Administrative Committee for the TIR Convention, 1975

**Accepted amendment proposals to the
Convention pending formal adoption**

Note by the secretariat

Sketch No.10.2

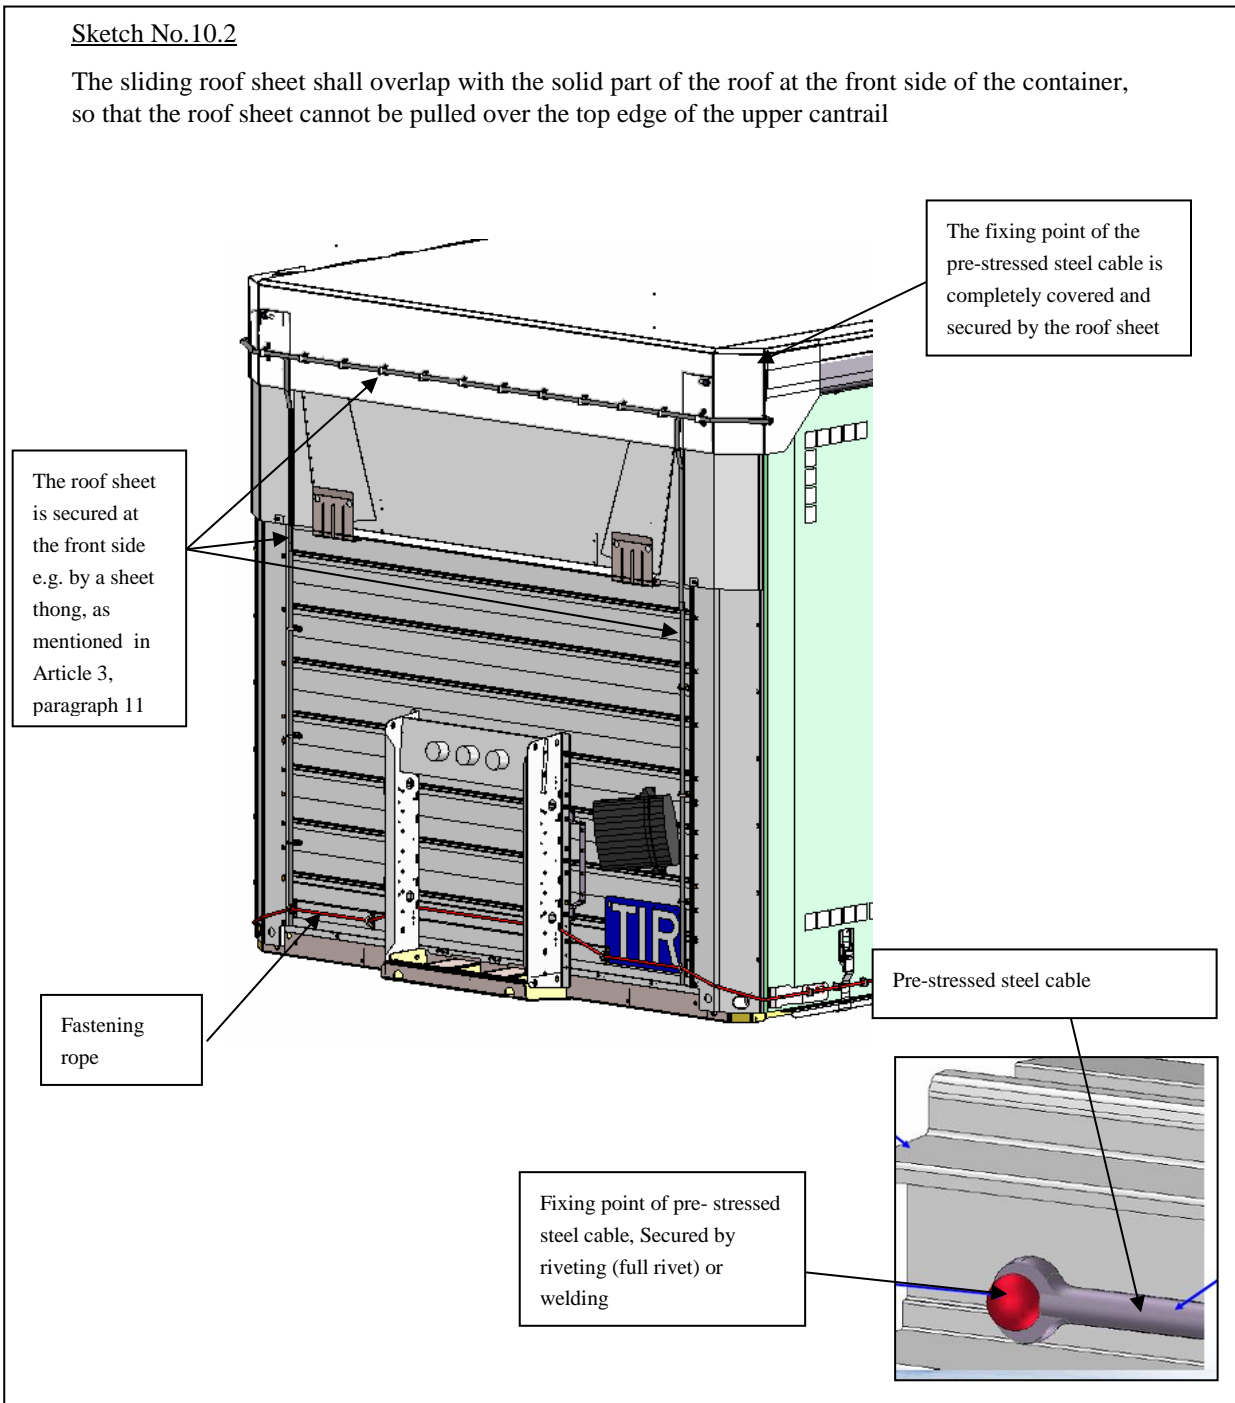
The sliding roof sheet shall overlap with the solid part of the roof at the front side of the container, so that the roof sheet cannot be pulled over the top edge of the upper cantrail
